DART SERVICE INSTRUCTION

TO AMEND INSTALLATION INSTRUCTIONS II145-6 Rev. A or later,

FIGURE 2: RH CABLE CHANNEL RELAY INSTALLATION LOCATION

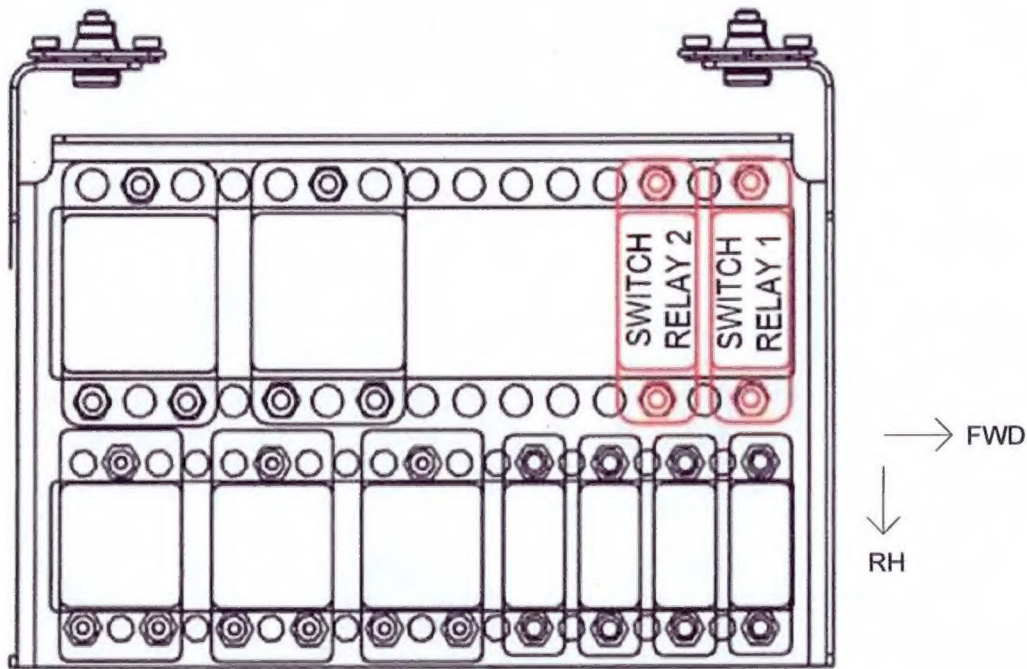
It has come to DART's attention that the wiring associated with the 654.6700 Float Kits is missing a relay, which may cause the automatic float switch to fuse in the open or closed position, rendering the system ineffective. Furthermore, a second relay is required to ensure sufficient independence between the float activation switches on the cockpit controls and the water activated switches when the manual pull cable is not installed. This DSI provides parts and instructions for upgrading the Auto Inflation Kits 654.6712, 654.6713, and 654.6719/654.6720 electrical activation assemblies to their revised configurations as defined by 651.4100 Rev. P or later Electrical Activation System.

1. Install two relay sockets (P/N 601.1682) into the relay holder in the cable channel on the FWD RH side of the aircraft as shown in Figure 1 and Figure 2 of this DSI.

1. Install one relay socket (P/N 601.1682) into the relay holder in the cable channel on the FWD RH side of the aircraft as shown in Figure 1 and Figure 2 of this DSI.
2. Install one relay (P/N 601.1627) into the relay socket.
3. Route wire 4102-M20 from the Instrument Panel to the relay at pin A2.
4. Splice wire 4101-M20 to SPDA9 and route to the relay pin X1.
5. Route wire 4103-M20 from splice SPDA1 to the relay pin X2.
6. Splice wire 4125-M20 to SPDA6 and route to relay pin A1.
7. From splice SPDA6, route wire 4107-M20 to connector pin A and wire 4124-M20 to connector pin C.
8. Wire 4104-M20 that is spliced to SPDA2 will now be routed to SPDA8 and from there to ground.

1. Install one or two relay sockets (P/N 601.1682) into the relay holder in the cable channel on the FWD RH side of the aircraft as shown in Figure 1 and Figure 2 of this DSI.
